Access Compliance Report

Public Rights-of-Way

Intersection ID: 24840	Main Street: REA_RD	Cross Street: MACANDREW_DR	Location: SW
ADA ID: 85E798251E18	Ramp Type: Directional1	Initial Pass/Fail: Fail	Overall Compliance: No
		Severity Score: 1.25

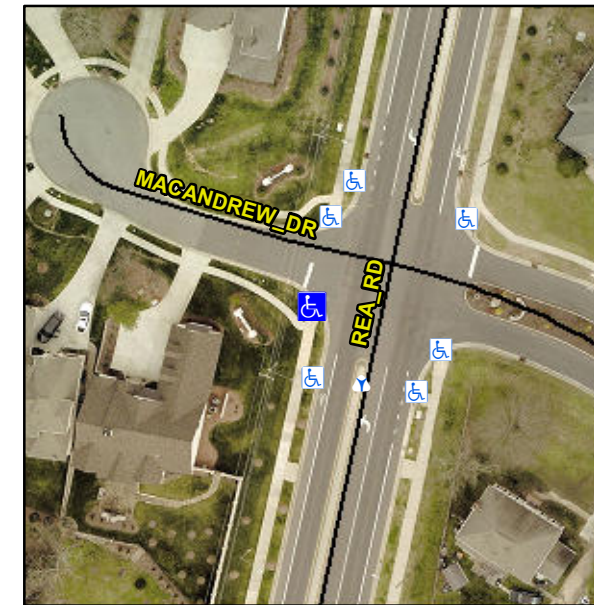
PROW/ADA:

R304.5.3

Compliance	Description	Data	Compliance	Description	Data
N/A	Ramp Length (in)	96.0	N/A	Grade Break?	N/A
Yes	Ramp Width (in)	72.0	N/A	Grade Break Slope (%)	0.0
Yes	Ramp Slope (%)	4.2	N/A	Grade Break XSlope (%)	0.0
No	Ramp XSlope (%)	2.5			
N/A	Flare Type LT	N/A	N/A	Flare Type RT	N/A
N/A	Flare Slope LT (%)	N/A	N/A	Flare Slope RT (%)	0.0
N/A	Flare Traversable LT?	N/A	N/A	Flare Traversable RT?	N/A
N/A	Landing Length (in)	0.0	N/A	DWS Provided?	N/A
N/A	Landing Width (in)	0.0	N/A	DWS Contrast?	N/A
N/A	Landing Slope (%)	0.0	N/A	DWS Length (in)	N/A
N/A	Landing X Slope (%)	0.0	N/A	DWS Full Width?	N/A
N/A	Landing Curb? (Y/N)	N/A	N/A	DWS Offset LT (in)	N/A
N/A	Shared Landing?	N/A	N/A	DWS Offset RT (in)	N/A
N/A	Gutter Ponding?	0.0	N/A	Gutter Slope (%)	N/A
N/A	Gutter Lip Ht (in)	0.0	N/A	Gutter X Slope (%)	N/A
N/A	Painted X Walk1?	No		Road Slope (%)	1.2
	X Walk 1 Direction	To N		Road X Slope (%)	2.7
	X Walk 1 Width (in)	N/A		Clear Space?	N/A

Possible Solutions:

Remove & Replace Entire Ramp.
